T21SA00085 DRB-21-11 Case Number DDO-21-19

DESIGN DEVELOPMENT OPTION (DDO) APPLICATION

City of Tucson Fire Station 18 - Project Description

ADDITION TO FIRE STATION 18 CITY OF TUCSON

Addition to Fire Station 18 City of Tucson SITE PLAN

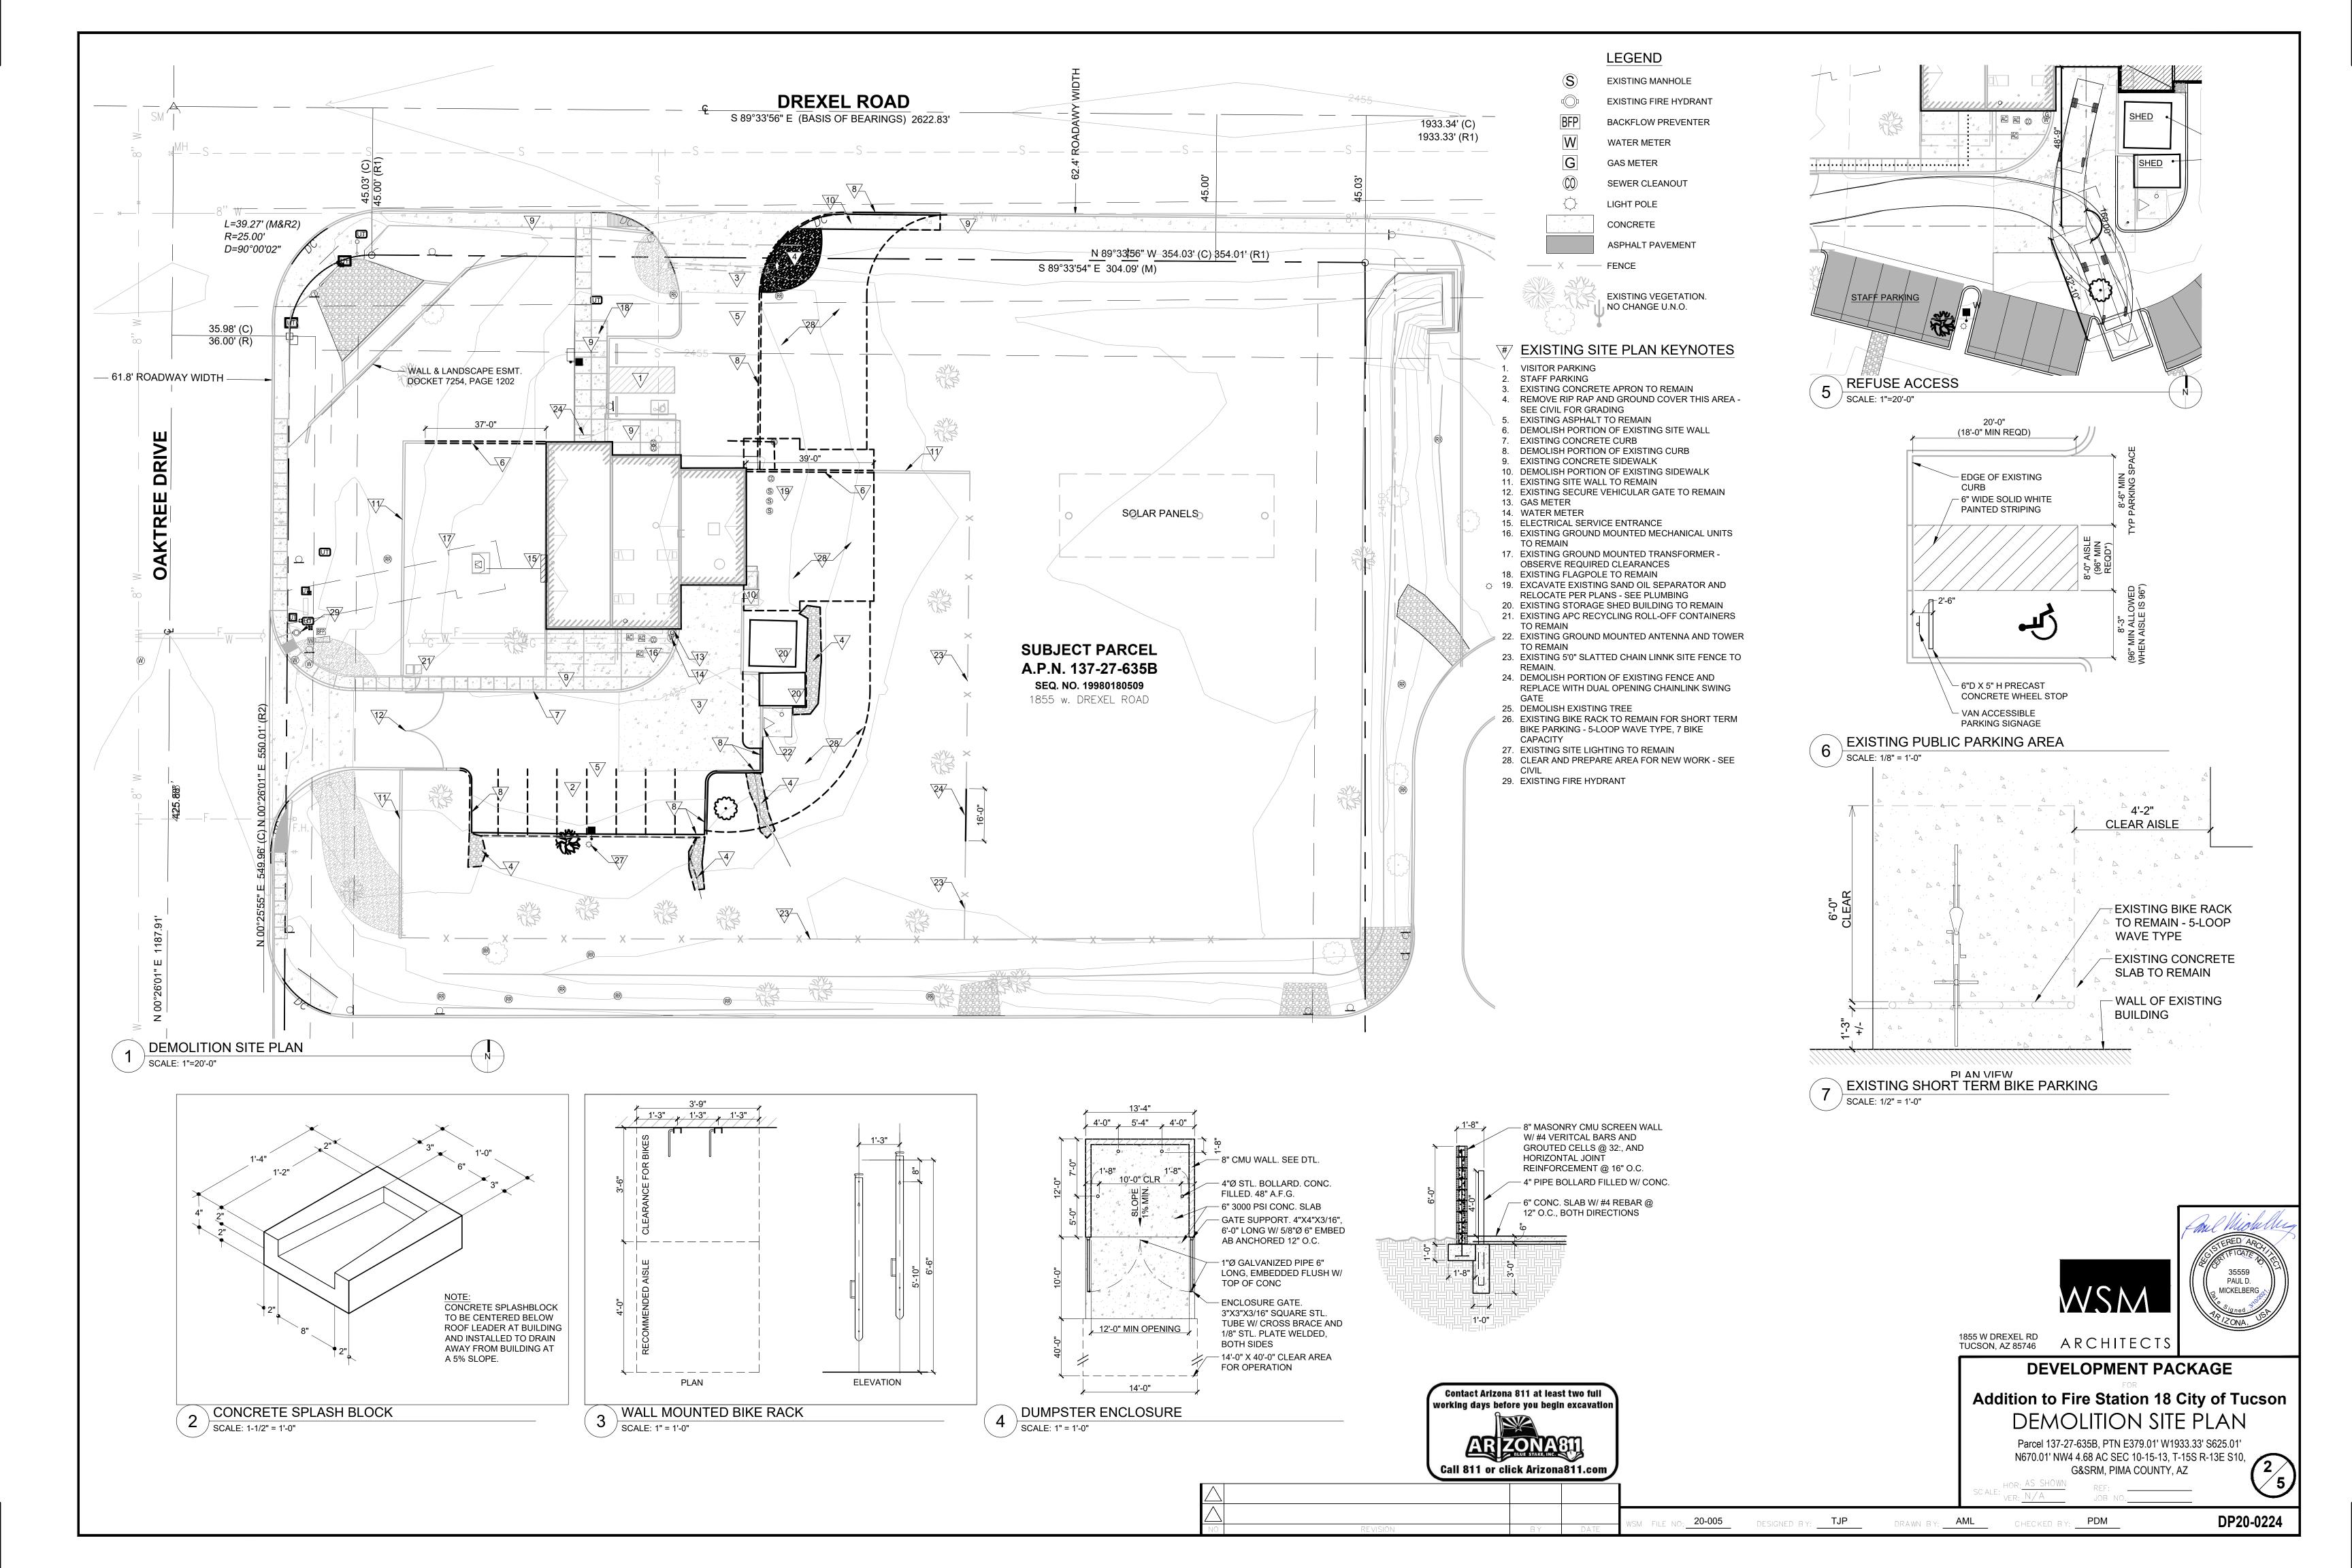
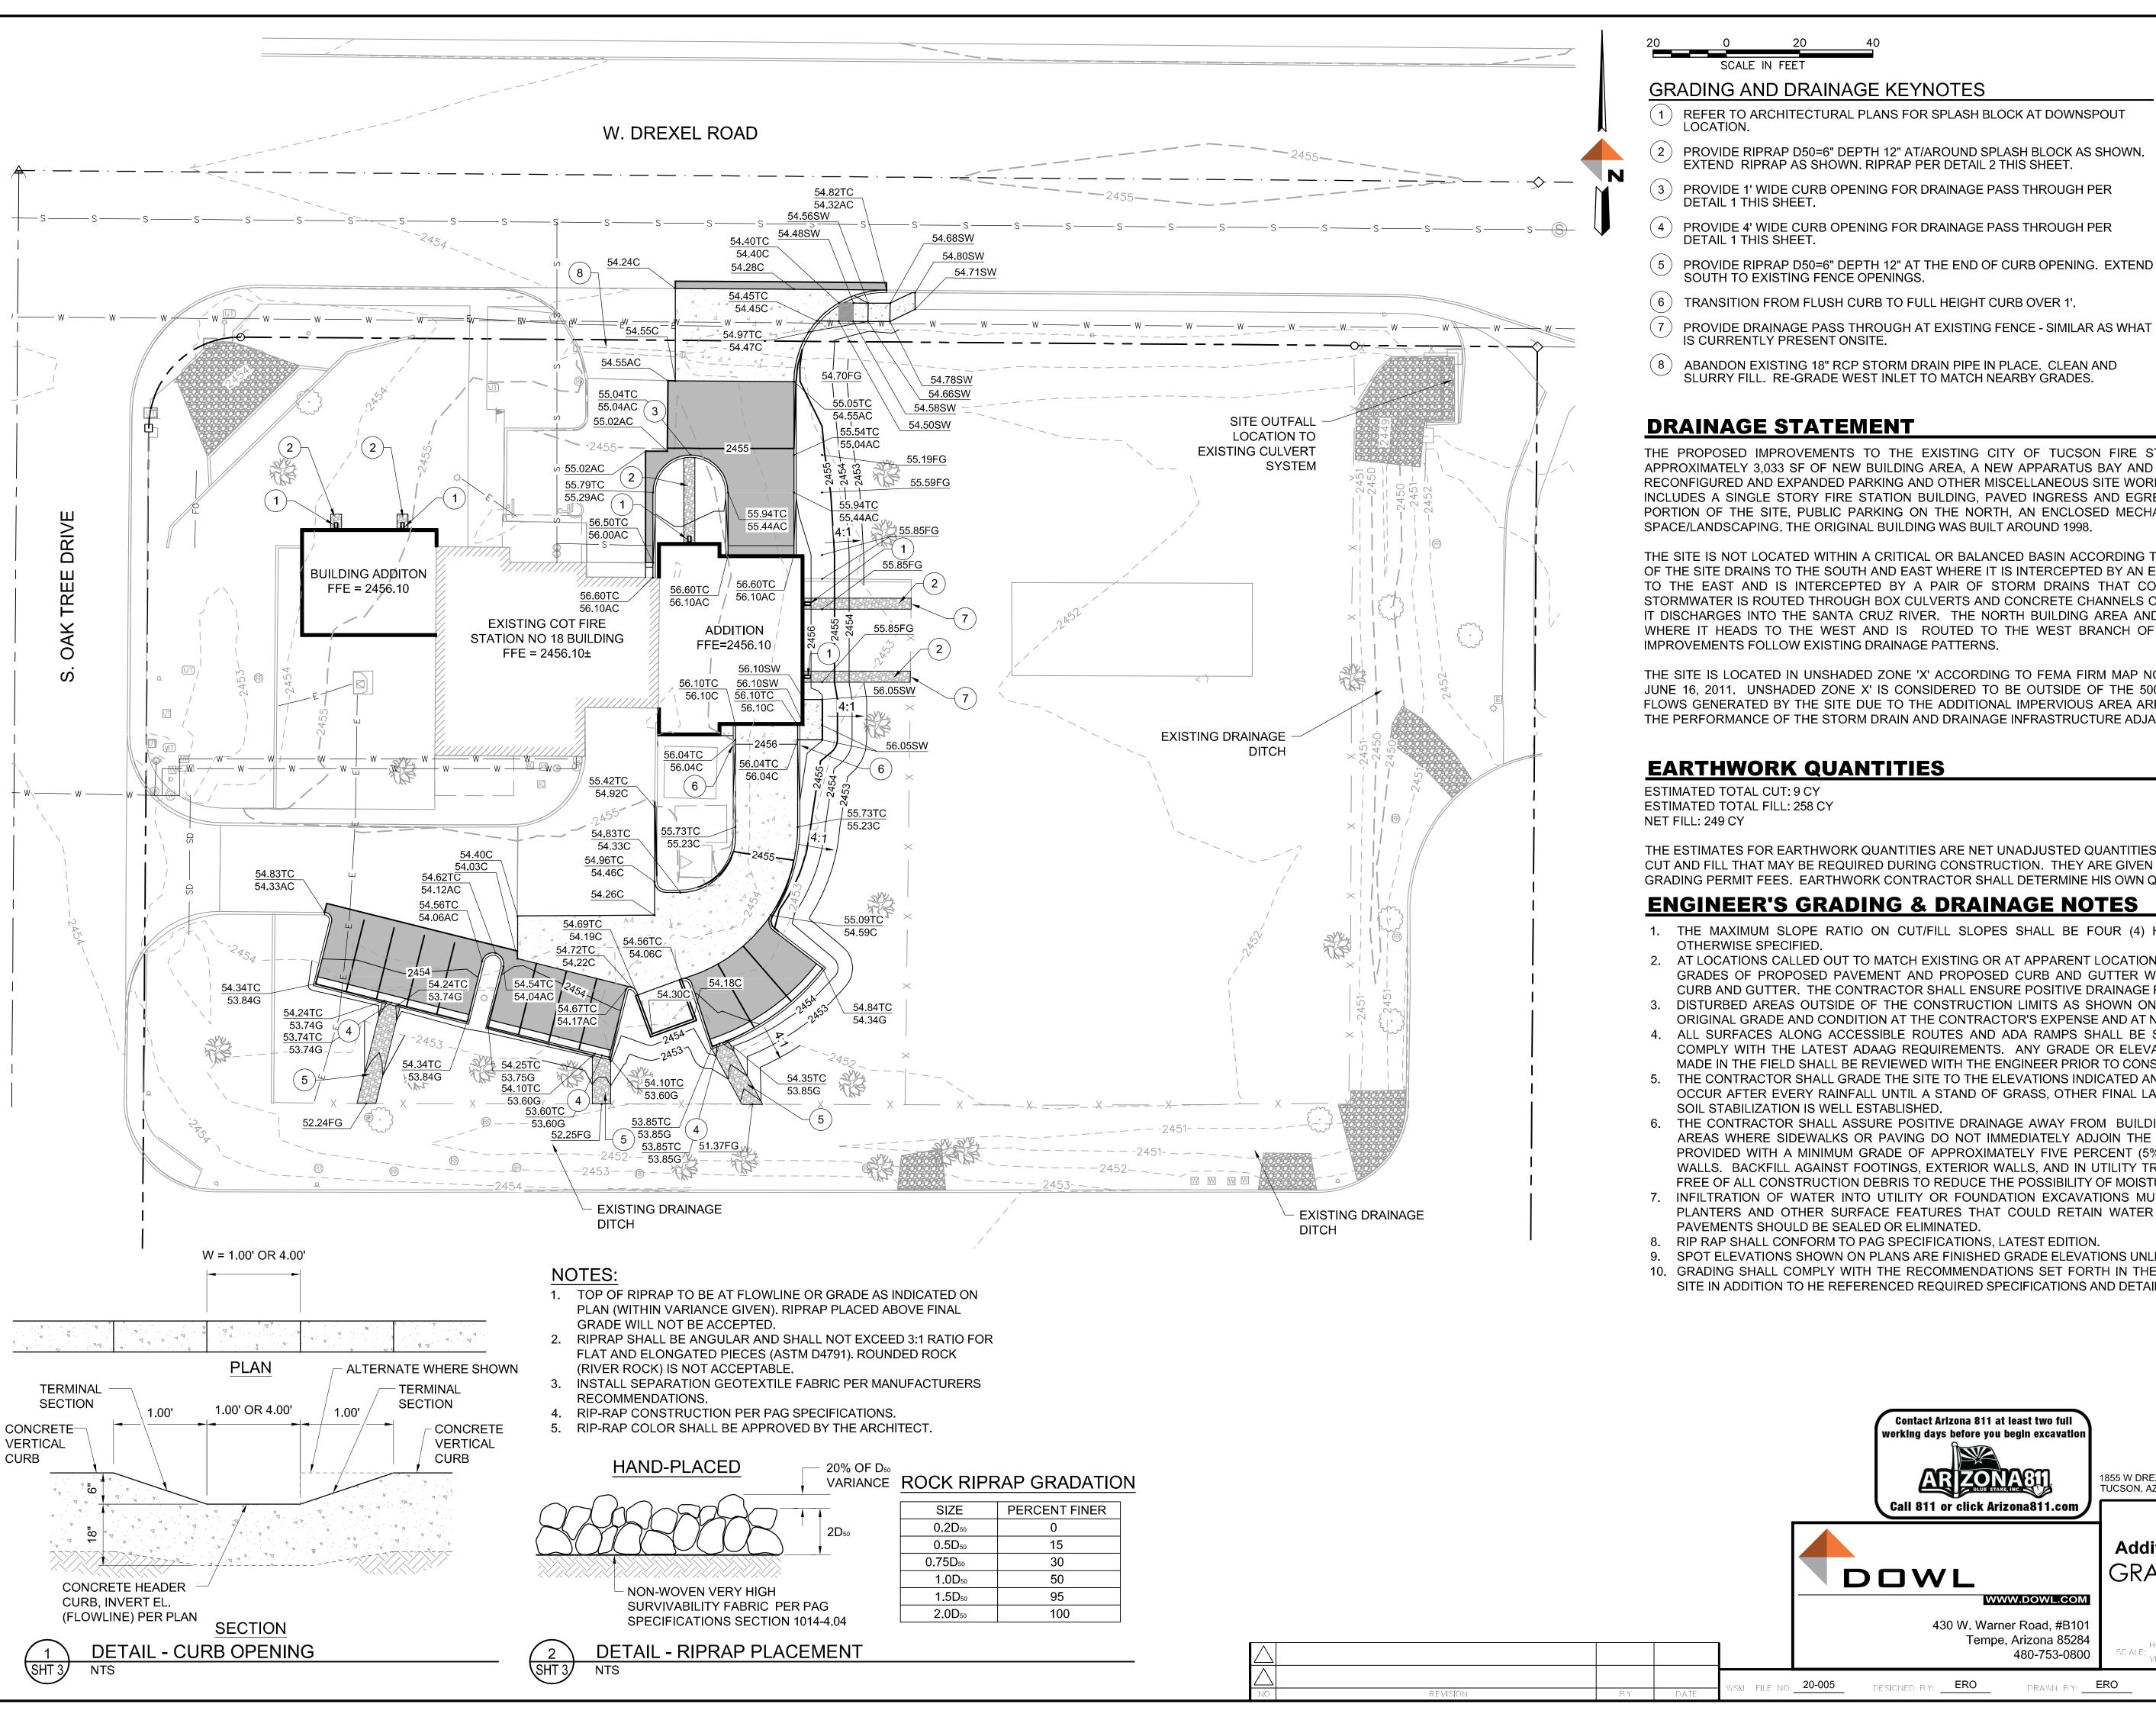
- 2. 2-06.4.3 Provide assigned case number DP20-0224 adjacent to the title block on each sheet.
- 3. 2-06.4.4.A Correct the location map on upper right of sheet 1 to show the subject property approximately centered within the one square mile area and correct section numbers to the north of Drexel Rd.

- 4. 2-06.4.7.A.4 Identify the existing and proposed use of the property as classified per the UDC. List all UDC sections applicable to the proposed uses. Demonstrate compliance with use-specific standard 4.9.13.F. which requires a minimum 5 ft screen wall on the portion of the site abutting a residential property, in this case it would apply to the eastern fence/wall adjacent to the fire station. This must be a solid, opaque wall, unless modified through a variance (deletion of the requirement) or constructed of another material (chain link and slats) and modified through a Design Development Option (DDO), which is an administrative process. The DDO request would be for a substitution of materials to include slatted chain link fencing and vegetation in lieu of a solid wall. Contact Mark.Castro@tucsonaz.gov for more information on either of these options.

- 5. 2-06.4.7.A.8.a, b, c Update general notes on sheet
 1. Include existing storage buildings on east of property,
 which appears to be approximately 150 200 sq ft. each.
 Update notes on floor area for each building, Percentage
 and area in square feet of building and accessory
 building coverage, and Percentage of building, lot area,
 or vehicular use area expansion.

- 6. 2-06.4.8.A Provide site boundary/subdivision perimeter information, including bearing in degrees, minutes, and seconds, with basis for bearing noted, together with distances in feet, to hundredths of a foot, or other functional reference system. Provide information for the entire parcel, not just the northern portion. This can be added to the site plan map above the legend on

- 11. 2-06.4.9.H.5.a Correct notes regarding calculations on the number of parking spaces required (include the ratio used) and the number provided, including the number of spaces required and provided for the physically disabled. Parking is based on gross floor area of all structures, including the existing storage building. Please note, GFA does exclude vehicle use area (garages). Based on rough calculations, it appears approximately 13 parking spaces are required. Please verify this calculation and correct on the site plan.

such as erosion hazard, floodplain detention/retention basins, and zoning, including sight visibility triangles, will be shown. Correct setbacks (lines and general notes) for Drexel Rd and Oak Tree Rd. As both streets are a Major Street and Route, developing area setbacks are applied as found in UDC Article 6.4.5.C.2. Setback from both streets is 21 ft or the building wall height (whichever is greater) as measured from the back of future curb.
